**SITE PLAN REVIEW**  
9/13/21 Plan Commission Meeting

**Taco Bell Restaurant / Sundance Inc.**

Village Planner Report

RE: Taco Bell Proposal for N96 W17801 County Line Road;  
Site Plan Application Staff Review Comments

**WEST ELEVATION**  
 SCALE: 1/4" = 1'-0"

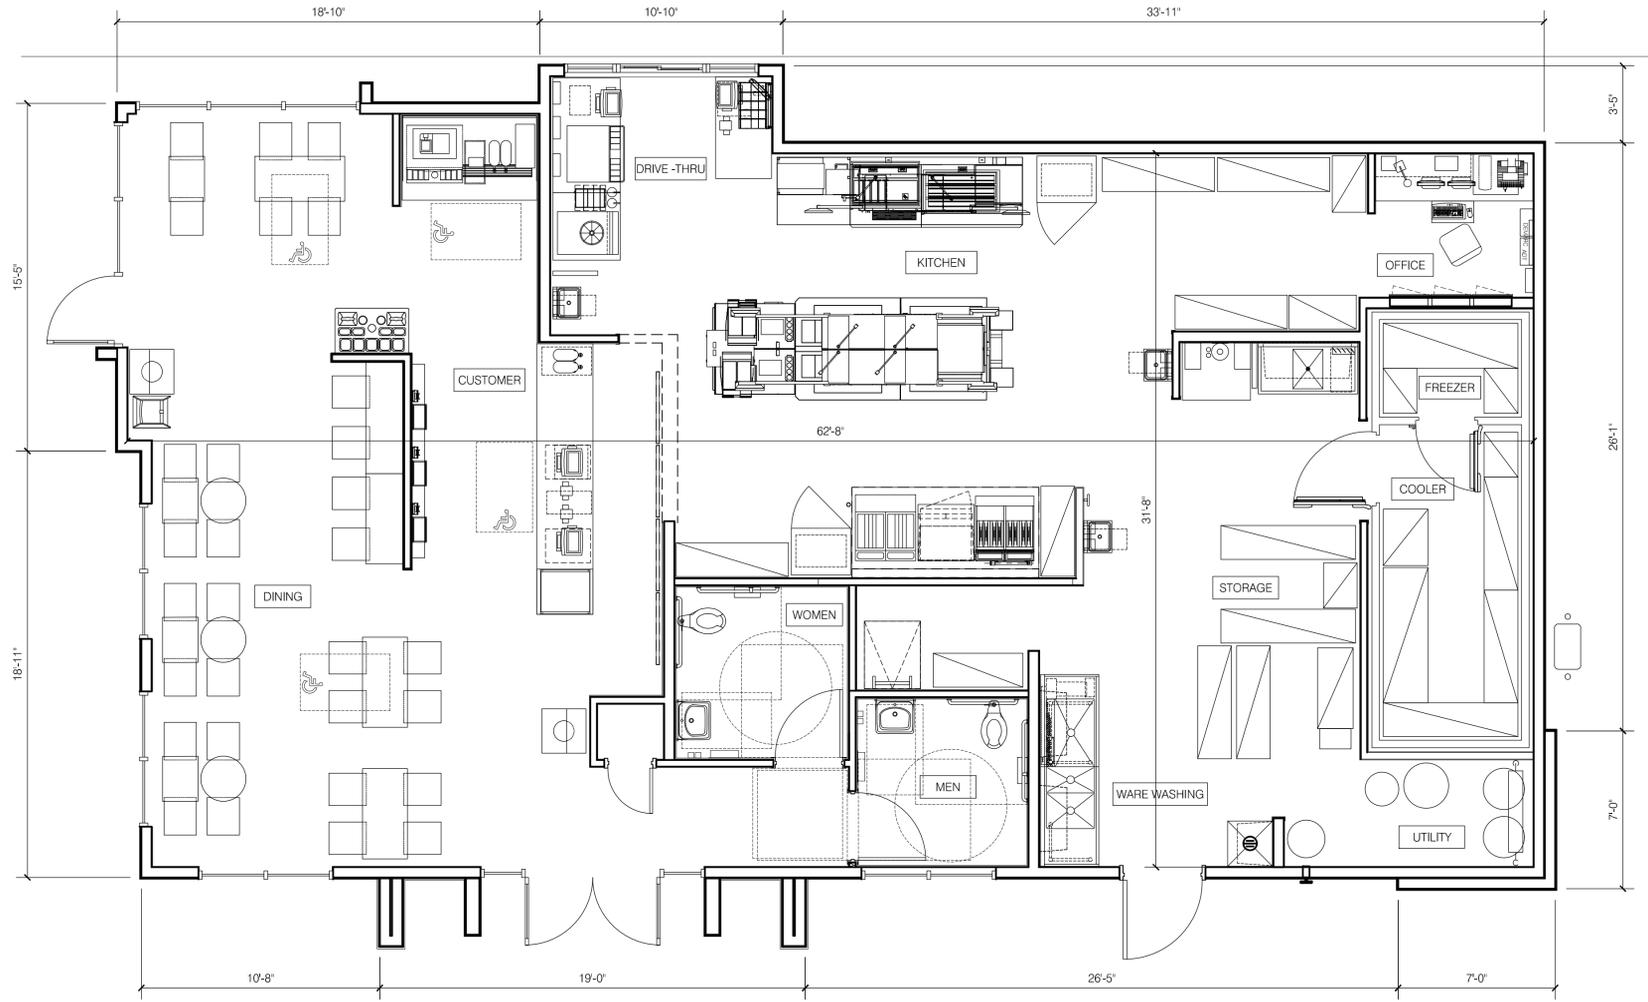
- The west elevation is plain and uninteresting; weak when compared to the other elevations. There is no room to install landscaping to soften the plain

appearance given the parking stall arrangement. Can you add some element to either the tower below the sign and/or the tan wall to liven it up? (other than a purple man door)

- The west elevation has been revised to provide additional articulation and the concrete walk at the west side is not required as the door from the back of house has been moved to the north side. This will allow foundation landscaping to be added along the west elevation to add interest and soften the façade.

**FLOOR PLAN** 1/4"=1'-0" **A**

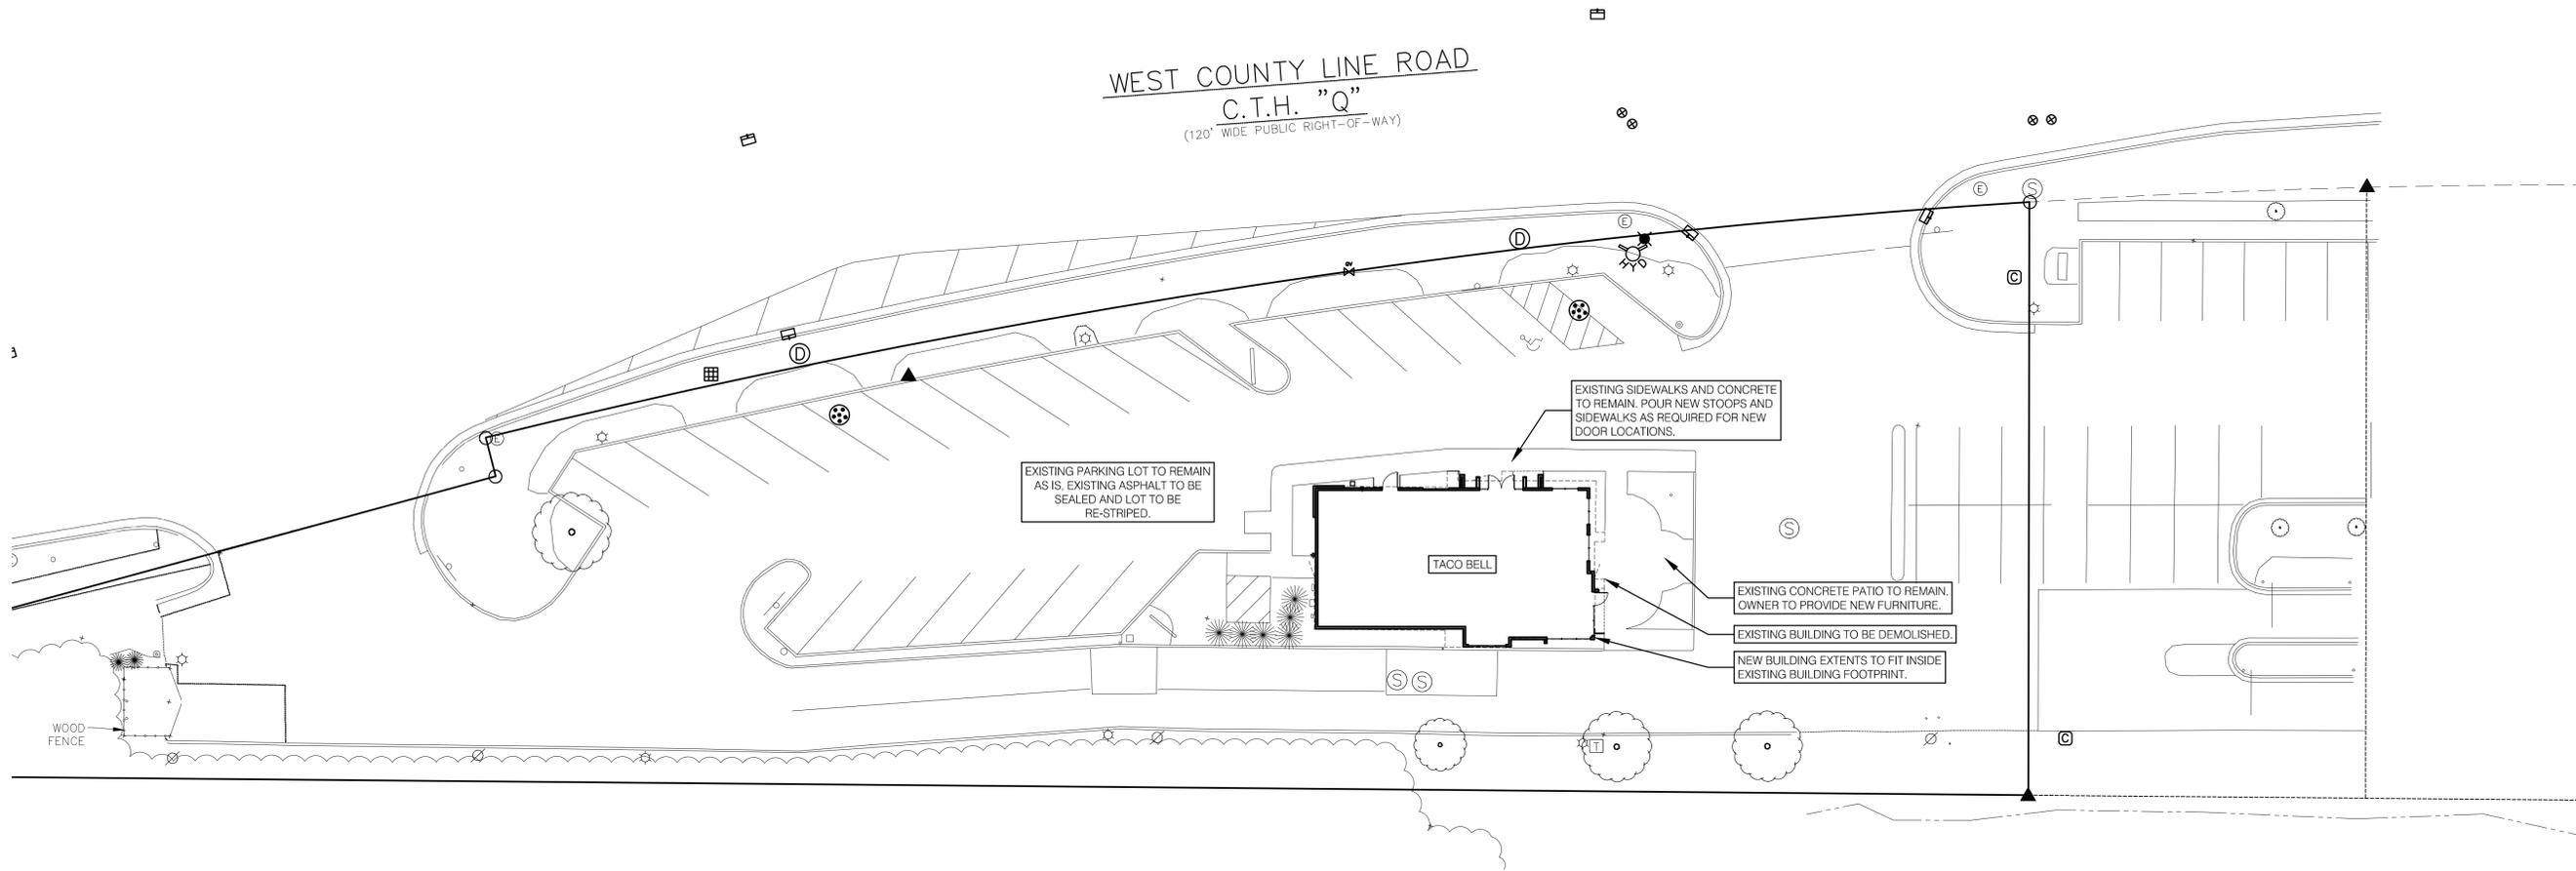
- The east and north renderings don't match up with the floor plan; exit man doors are shown on both the east and north sides of the floor plan but not in the elevation renderings.

- The renderings have been revised to match the floor plan.
  - Will there be an outside dining/seating area? (existing concrete pad is shown as being preserved)

**C1.4**

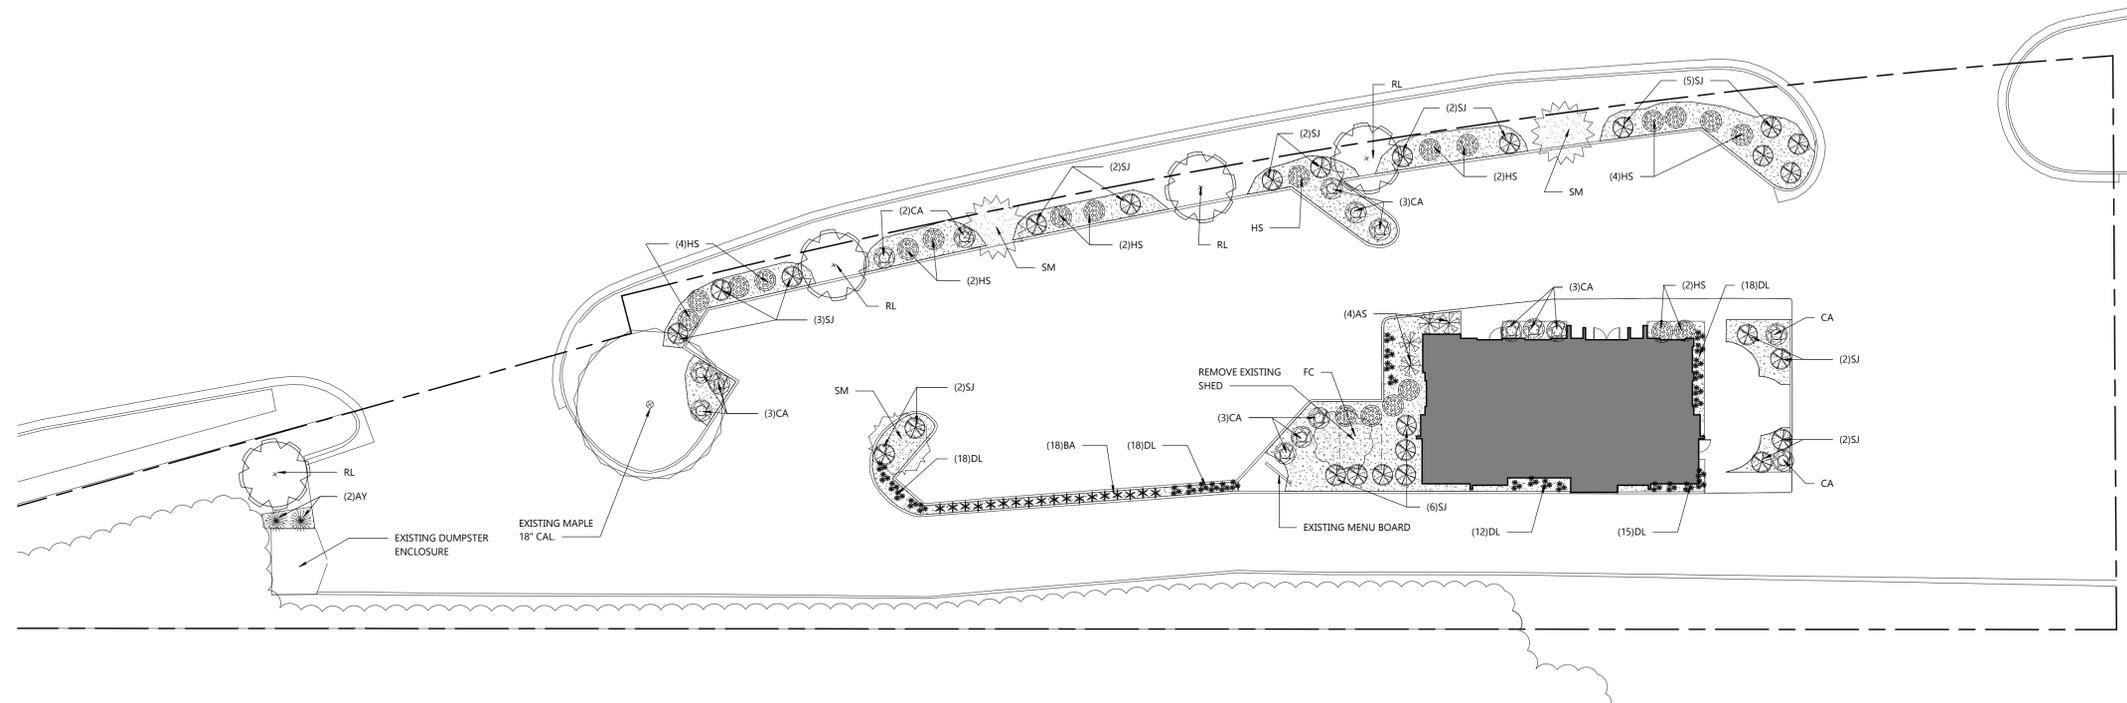
1. The original set of site plans approved for the existing Taco Bell store included a detailed landscape plan (copy attached) that, presumably, was carried out and the site landscaped accordingly. However, as shown in the attached photos, all the landscaping (trees, shrubs & plants) in those areas on the site have since been removed and replaced with decorative stone... and nothing else. At a minimum, the landscaped areas in the original landscape plan will need to be restored/replanted with the same or similar items... if not an improved landscape plan. This is/has been a common problem for many commercial sites along County Line Road. In response, the Village has been requiring owners to restore their properties with the same or better landscaping plan as was originally approved at the time those businesses re-model or re-develop their properties. A good example is the Burger King store next door. They, too, were required to re-landscape as part of their 2018 building remodeling project. The landscape plan that was approved for the Burger King property is the best example of what the Plan Commission is looking for and would approve. A landscaping plan needs to be prepared and included.

1. The original set of site plans approved for the existing Taco Bell store included a detailed landscape plan (copy attached) that, presumably, was carried out and the site landscaped accordingly. However, as shown in the attached photos, all the landscaping (trees, shrubs & plants) in those areas on the site have since been removed and replaced with decorative stone... and nothing else. At a minimum, the landscaped areas in the original landscape plan will need to be restored/replanted with the same or similar items... if not an improved landscape plan. This is/has been a common problem for many commercial sites along County Line Road. In response, the Village has been requiring owners to restore their properties with the same or better landscaping plan as was originally approved at the time those businesses remodel or re-develop their properties. A good example is the Burger King store next door. They, too, were required to re-landscape as part of their 2018 building remodeling project. The landscape plan that was approved for the Burger King property is the best example of what the Plan Commission is looking for and would approve. A landscaping plan needs to be prepared and included

- A landscaping plan is provided that uses the original landscape planting beds. Excel does not have access to the original landscape plan; however, if this plan does exist, the owner is willing to match the plantings from the original approved plan.
